**REVISED AGENDA**  
**WOODLAND PARK PLANNING COMMISSION**  
**Thursday, March 28, 2024, 6:30 P.M.**  
**Council Chambers – 220 W. South Avenue**  
**No Work Session**  
**All Items Rescheduled from March 14, 2024**

Since the initial approval of the new preliminary plat, on January 16, 2024 the City of Woodland Park Planning department issued Grading and Infrastructure Zoning Development Permits for the subject property. Below (Figure 2) is the approved Development Plan for the Pines at Stone Ridge. While a permit to begin grading and installation of the infrastructure has been issued, this work has yet to commence.

PINES AT TAMARAC PUD  
PUD AMENDMENT  
LOT 2 OF DAYSPRING CHRISTIAN FELLOWSHIP  
SITUATED IN THE NORTHEAST QUARTER OF SECTION 11, TOWNSHIP 12 SOUTH, RANGE 69 WEST OF THE 6TH  
P.M., CITY OF WOODLAND PARK, COUNTY OF TELLER, STATE OF COLORADO

COVER SHEET  
SHEET 1 OF 11

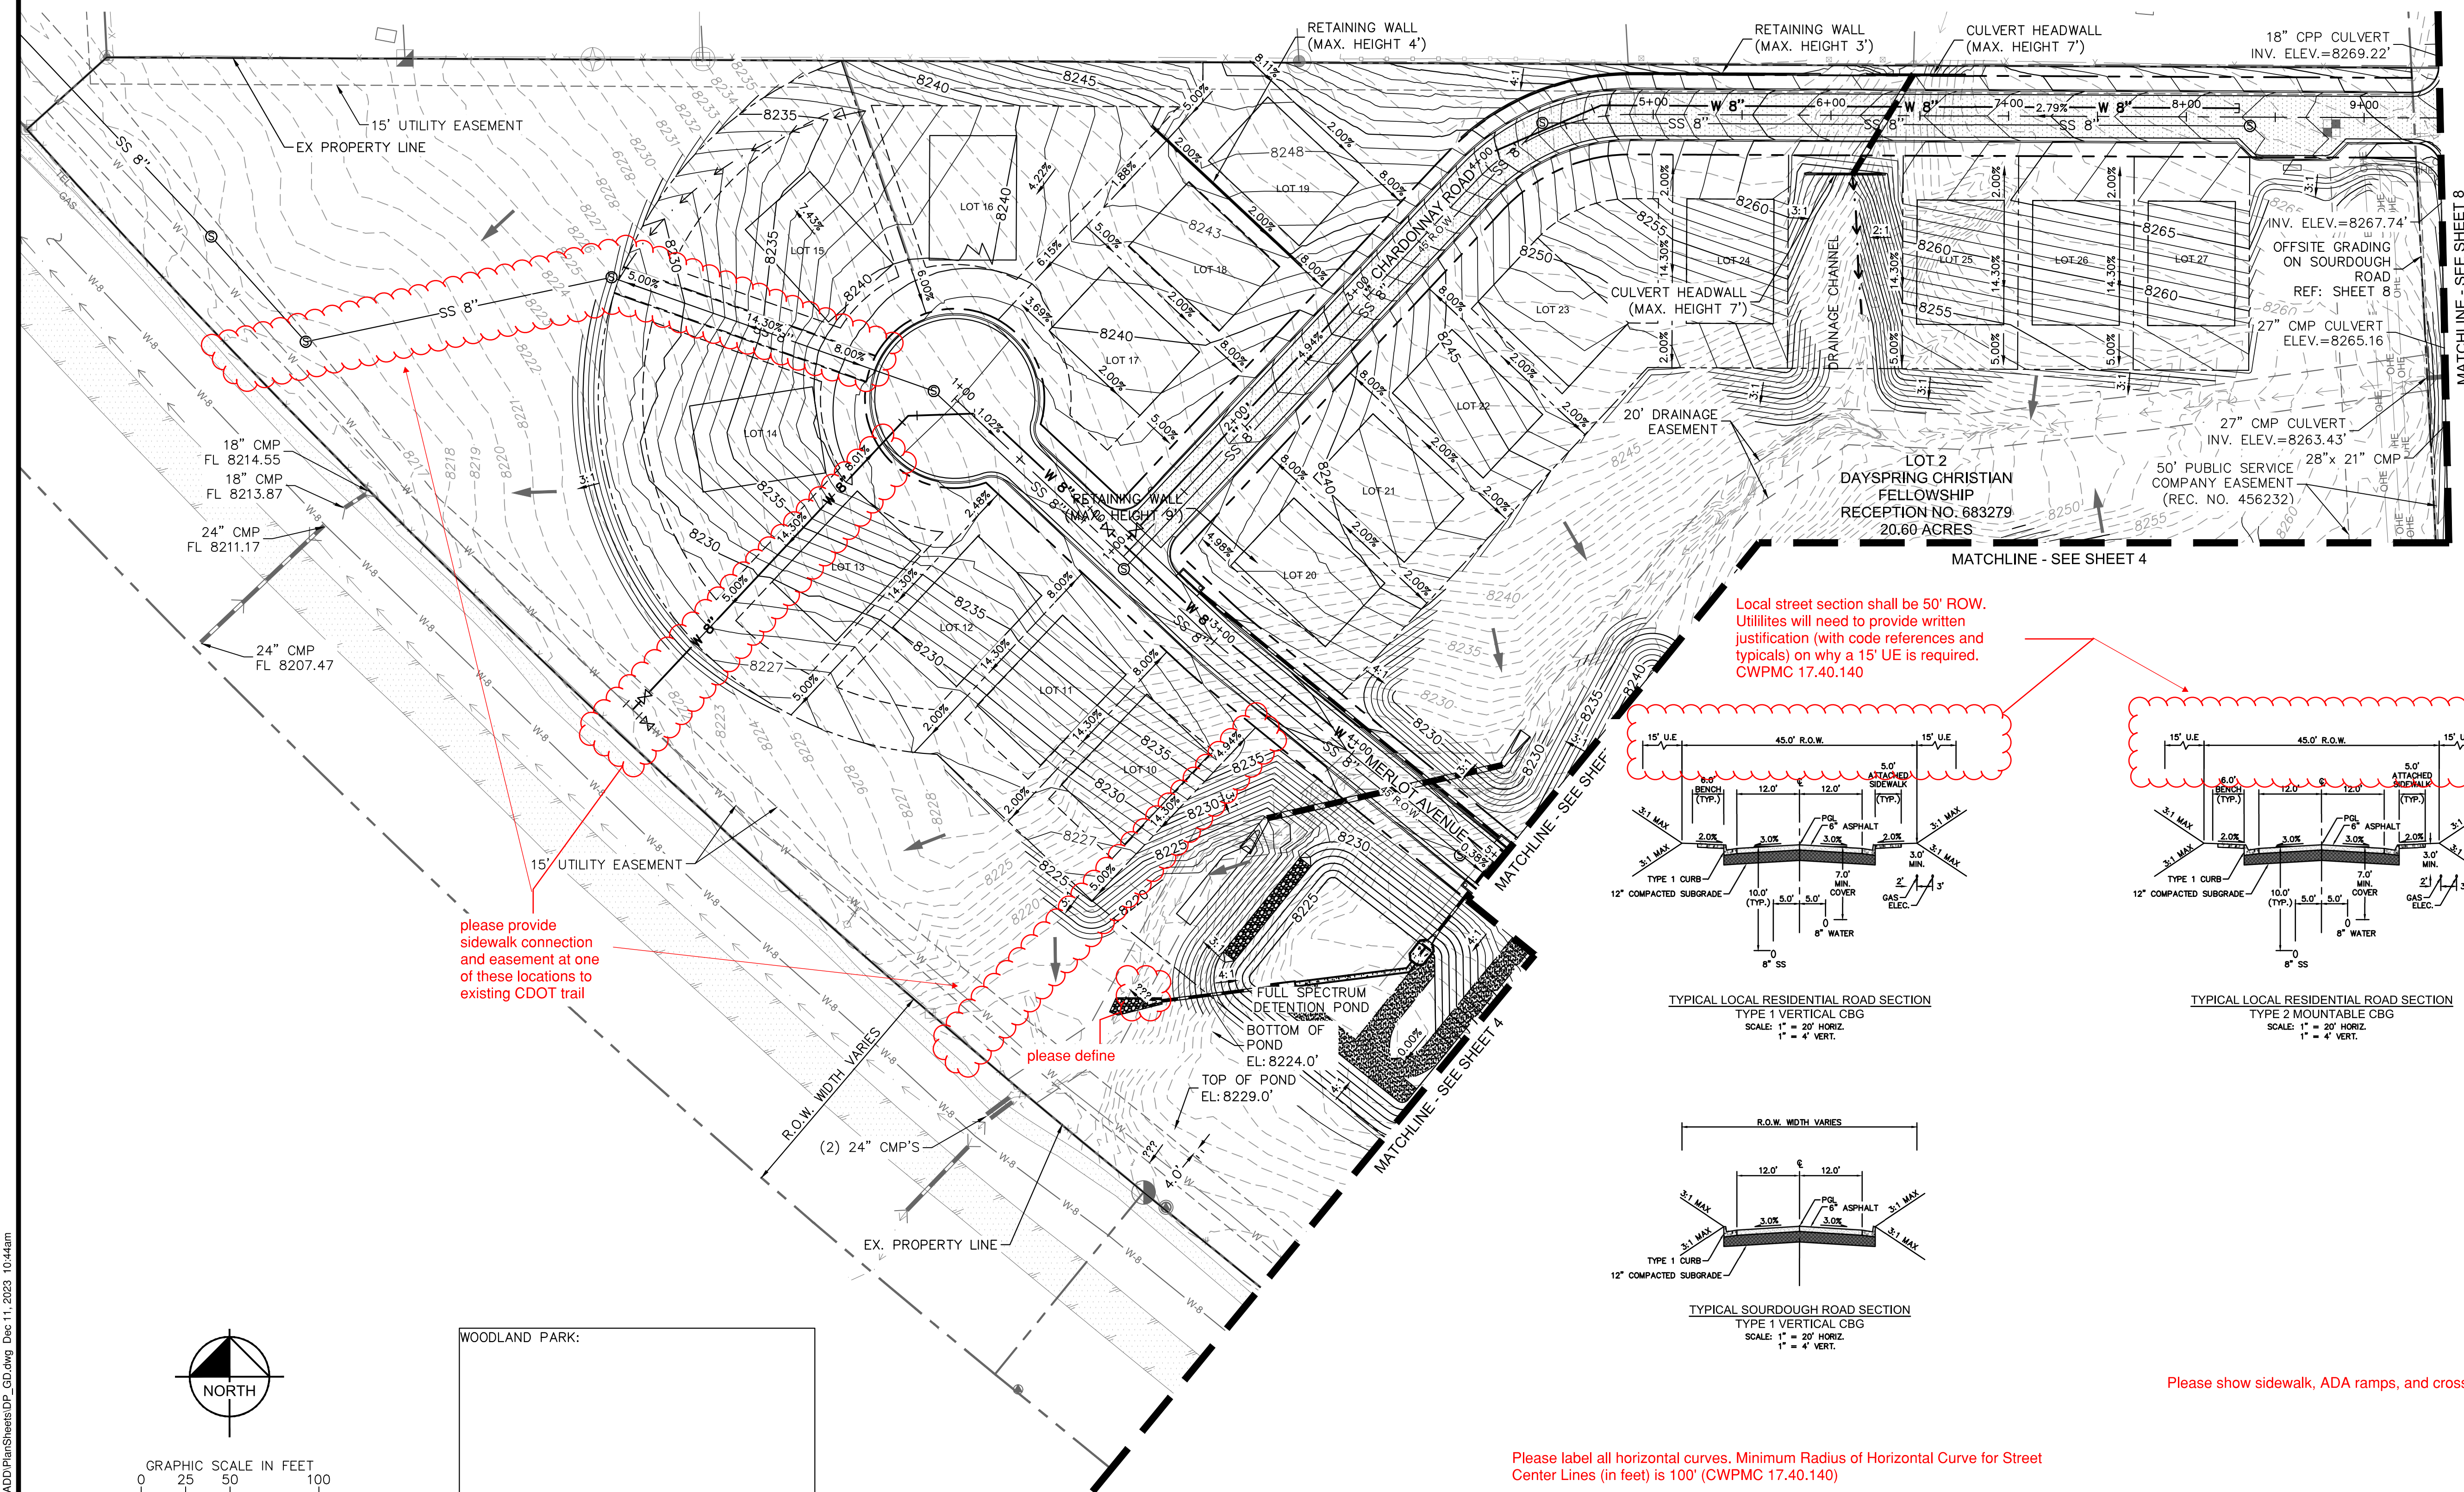
No more than 12 units on a dead end line.

Looping the water main and crossing the Highway?

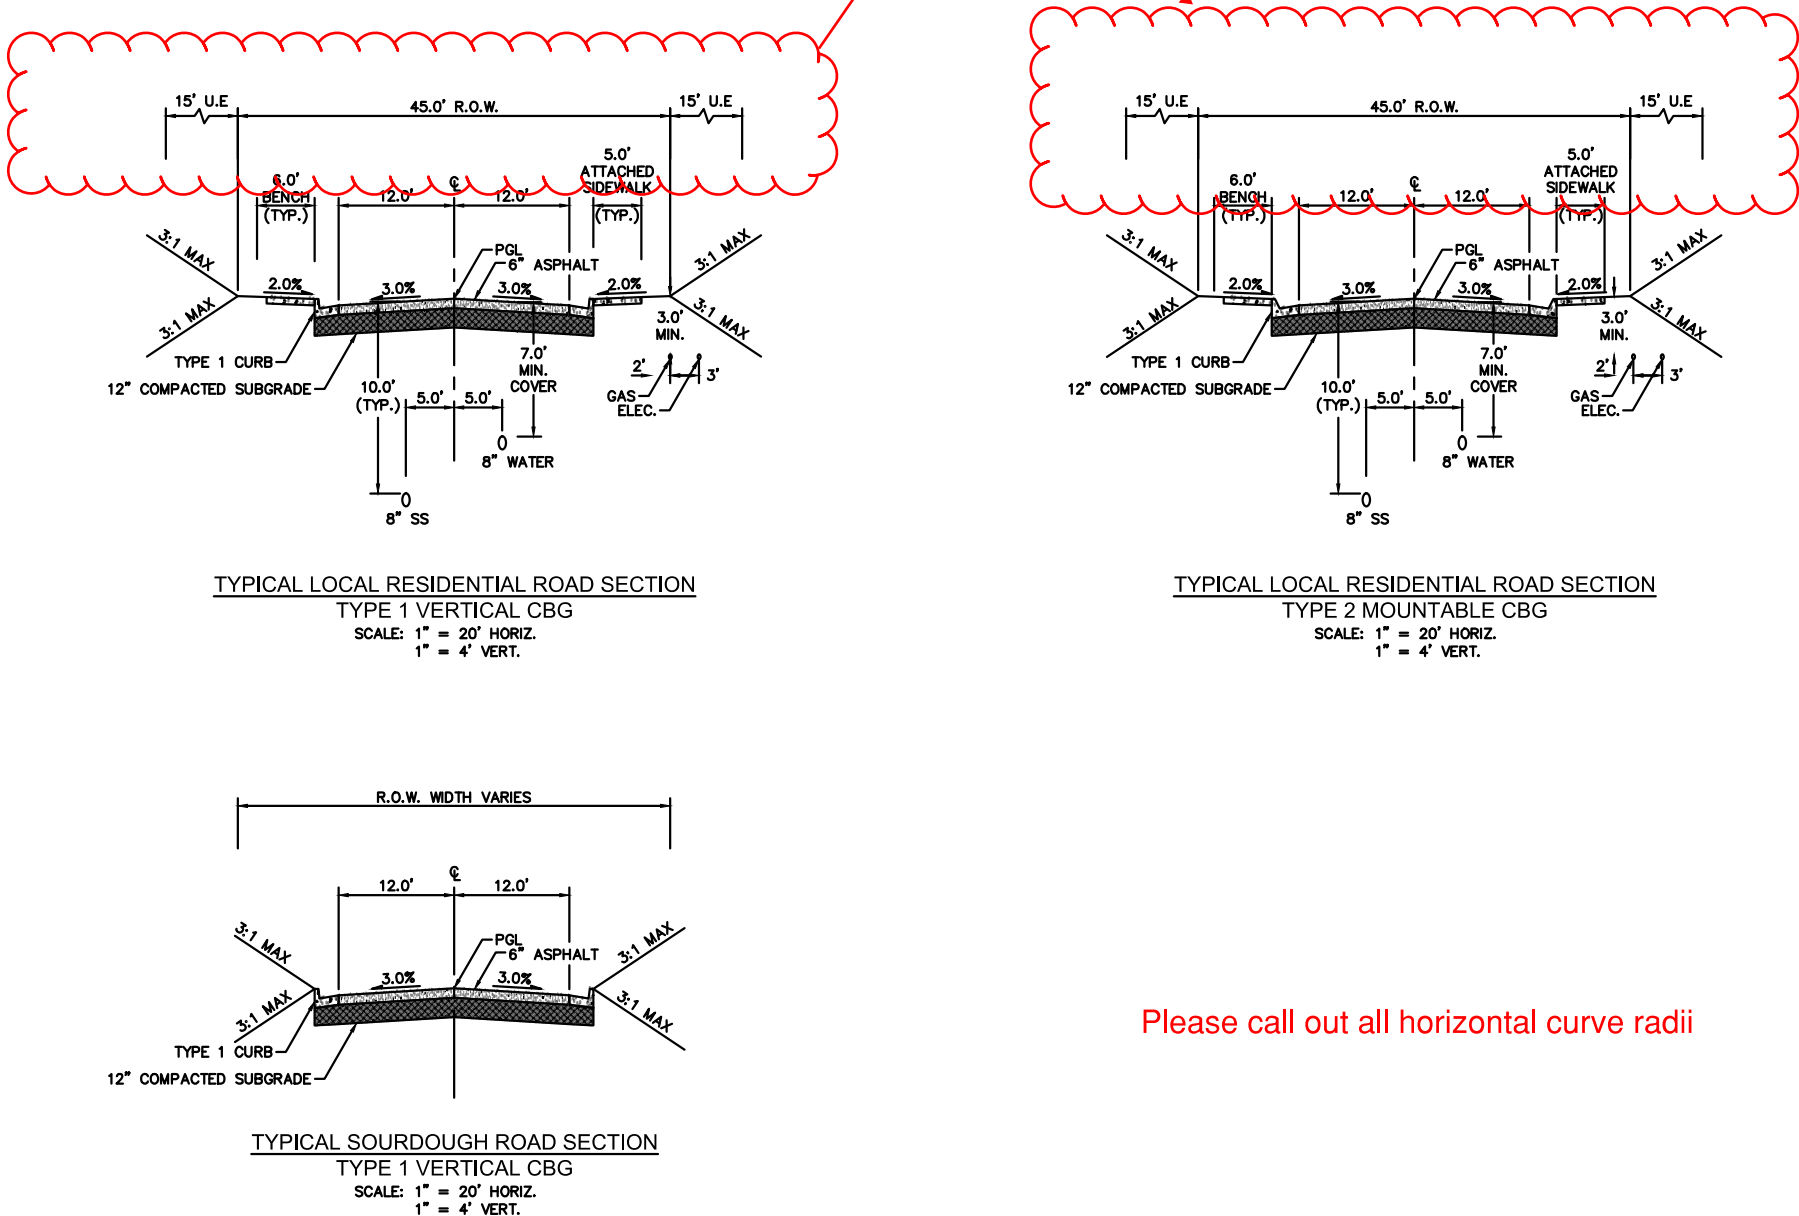
Please show sidewalk, ADA ramps, and crossings on plansets

Please label all horizontal curves. Minimum Radius of Horizontal Curve for Street Center Lines (in feet) is 100' (CWPMC 17.40.140)
